Responses to Colorado Department of Public Health and Environment Comments on the CDPHE Conservative Screen Letter Report for OU 3

95-DOE-08367

Figure 1 Trench 03492

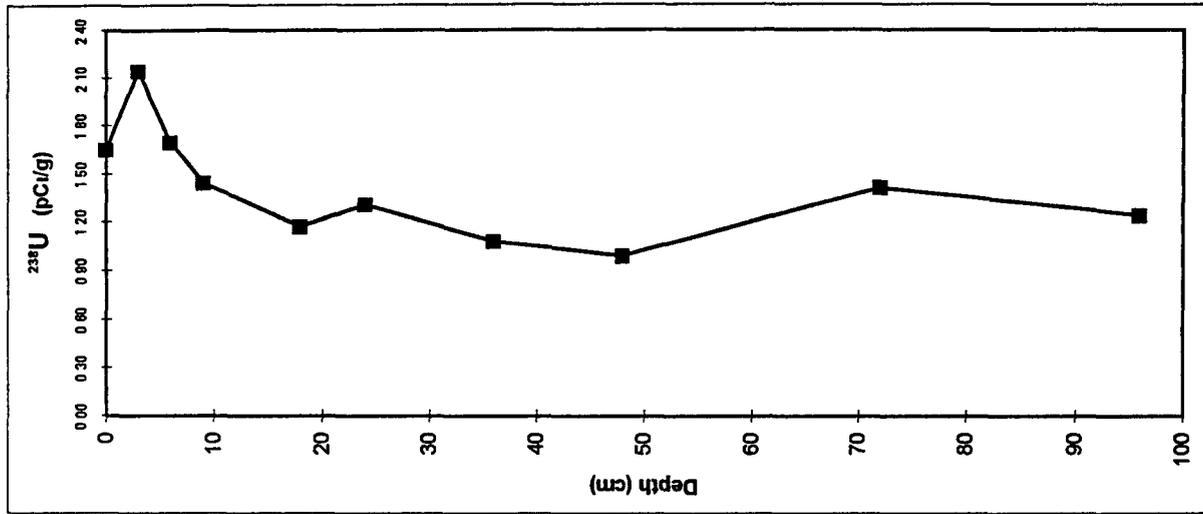
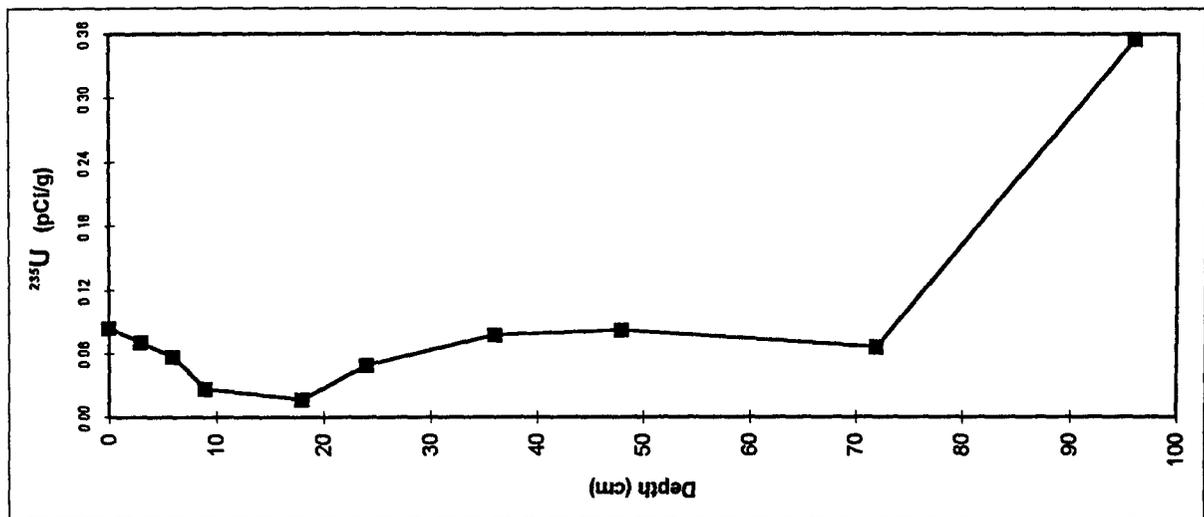
Additional analysis required: Clarify that subsurface soil (trench) data were considered in the CDPHE Conservative Screen; verify that maximum activities for ²⁴¹Am and ^{239/240}Pu are in surface soil, and that activities for uranium isotopes are at background levels.

Figures 1 and 2 show radionuclide activities with depth for the soil trenches TR03492 and TR03692. Activities for ^{241}Am and $^{239/240}\text{Pu}$ are greatest at the surface, with activities decreasing with depth to less than 0.01 pCi/g for ^{241}Am and 0.10 pCi/g for $^{239/240}\text{Pu}$ at a depth of about 10 centimeters. These subsurface soil depth profiles indicate that the presence of ^{241}Am and $^{239/240}\text{Pu}$ in OU 3 soil is the result of windblown deposition. Activities of the uranium isotopes show a different pattern, with levels of activities of $^{233/234}\text{U}$, ^{235}U , and ^{238}U varying over the entire depth of the trench samples at one location. The distribution of activities with depth for the uranium isotopes indicates variability associated with background conditions rather than wind-blown contamination from the Site. (Note: The majority of the uranium data for TR03492 were rejected by the independent data validators. These rejected data for TR03492 appear to follow the same pattern as TR03692 so they are included to show the complete depth profile.) Based on the analysis of levels and patterns of uranium activities in subsurface soil, $^{233/234}\text{U}$, ^{235}U , and ^{238}U were not retained as PCOCs for the CDPHE Conservative Screen. These analytes were also eliminated as PCOCs for soil based on analysis of the surface soil data set (see Section 2.3.1 of the CDPHE Letter Report for OU 3, September 23, 1994).

Figure 4

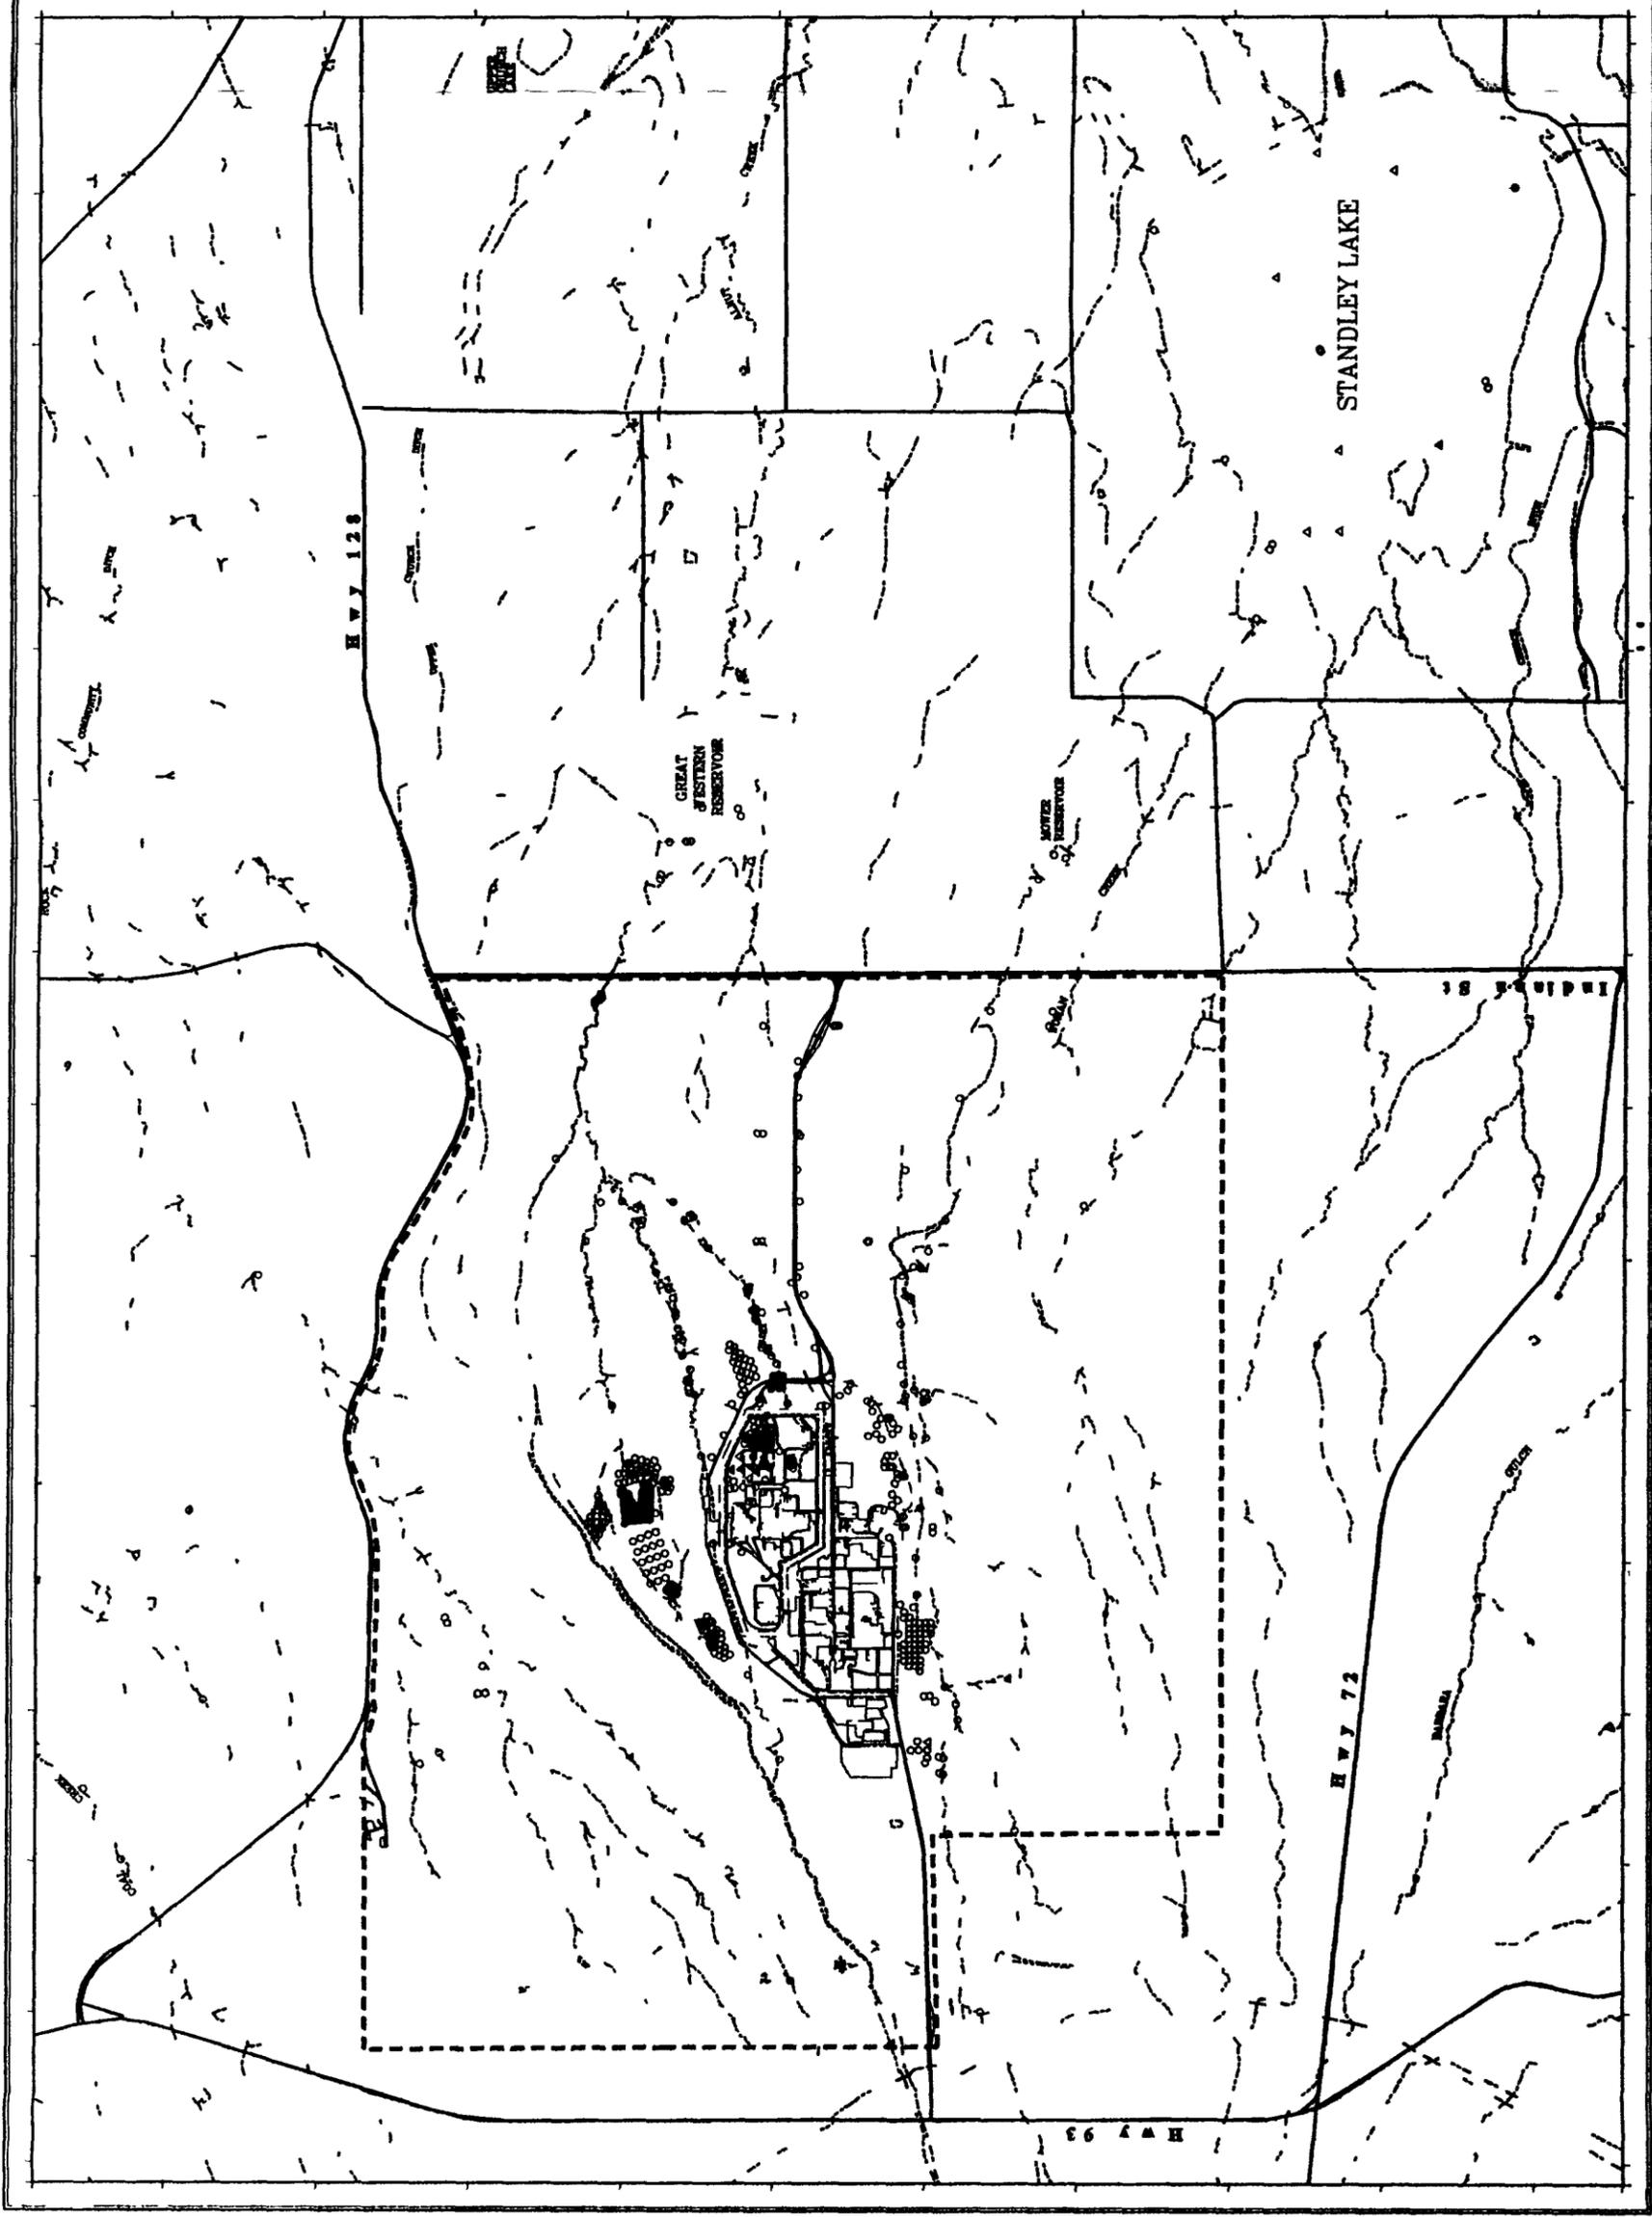
Step 2. Perform a spatial analysis for each metal analyte identified in Step 1. The spatial analysis will be presented on an 11 x 17 inch map that shows concentrations of metal analytes over the entire Site, including OU 3. Any metals that do not appear to be Site-related will be eliminated as PCOCs.

Figures 3 through 9 are maps that show site-wide concentrations of metals not eliminated as PCOCs by Step 1 described above (i.e., arsenic, cadmium, copper, lead, nickel, potassium, and zinc for Standley Lake and potassium for Mower Reservoir). For core samples in the reservoirs, the maximum value at each location is shown on the maps.

For the metal analytes shown on Figures 3 through 9, the majority of the samples collected within the Site boundaries and from OU 3 have concentrations below stream sediment UTLs reported in the Background Geochemical Characterization Report (DOE, 1993). In general, the highest concentrations for these metals tend to be in the deeper areas of Standley Lake. Natural limnological phenomena explain the slightly elevated concentrations of metals in the center of the reservoirs. The finer particles of sediment tend to have the highest concentrations of organic matter, and thus higher metal concentrations associated with the organic matter (Davis and Kent, 1990). These finer sediment particles in the water column also tend to deposit in the center of the lake where flow velocities can no longer support particle suspension.
